TOKIO MODE LTD (Extension)

27 November 2023

Observation-4: Falling hazard at roof level (Sample & Office Building)

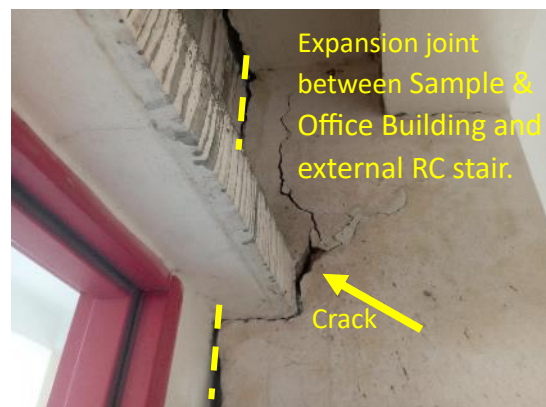
Description: Parapet/railing not found at roof level. The building engineer is required to provide edge protection to avoid falling hazard.
